Stormwater Pollution Prevention Plan Inspection Report

Project Name and Location: Blackwell

Weather: 78	☒ Cloudy ☐ Sunny ☒ Rain ☐ Snowing/ Snow cover
Date of inspection: 7/25/25	
Inspectors Name: Jessica Ekster	
Type of Inspection: ☐ Regular ☒ Rain event ☐ Other:	
Rain in last 24 hrs (inches): 4.92"	
Owner/Permittee: Griffin Riley	
Current Site Condition: Active

Problem Areas/Special Observations (Note problem areas ONLY below):

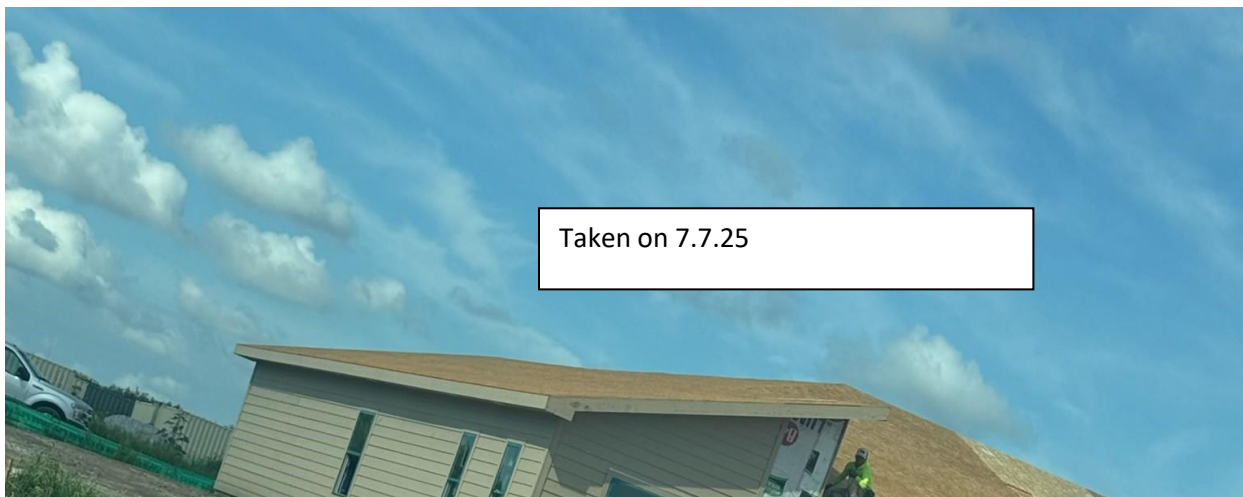
BMP	Location	Observation, Effectiveness, & Corrective Actions Ordered
Stabilize	In-active	Stabilize all areas that have been inactive for 14+ days- Weeds are not considered vegetation.
Stabilize	Swale	Stabilize swale on North end as soon as possible if work is done
Stabilize	Detention Ponds	Stabilize detention ponds asap- weeds are not considered vegetation
Silt fence	Detention Pond	Reset silt fence along detention pond behind Residences
Rock	Access Rd/Const. Entrance	Need more rock at construction entrance

BMP	Location	Observation, Effectiveness, & Corrective Actions Ordered
Streets	All	Clean streets and curbs
Silt fence	Along curb	Replace silt fence where torn through along curb
Inlets	Various	Clean inlets
Inlets	End of stub street near East side	Silt built up against inlet needs removed and silt fence in front needs reset/replaced
